SAEr

## **RATIONALE**

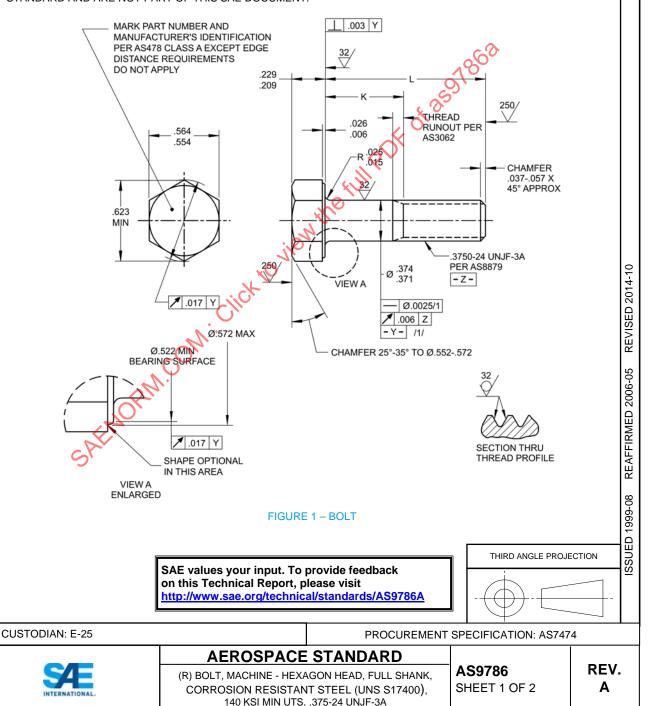
UPDATE THREAD SPECIFICATION TO AS8879, UPDATE TO ANSI Y14.5M-1982, REVISE FPI REQUIREMENTS TO ASTM E1417/1417M, ADD EDGE DISTANCE EXCEPTION FOR HEAD MARKING, REVISE ACROSS POINTS AND ACROSS FLATS DIMENSIONS, ADD AS3062 FOR THREAD RUNOUT, CONVERT GD&T NOTES TO FEATURE CONTROL FRAMES, DATUMS, AND SYMBOLS, ADD SURFACE TEXTURE REQUIREMENTS FOR TOP AND END, ADD SURFACE TEXTURE SYMBOLS PER ASME Y14.36M, FIGURE 1 REDRAWN AND GENERAL EDITORIAL UPDATE
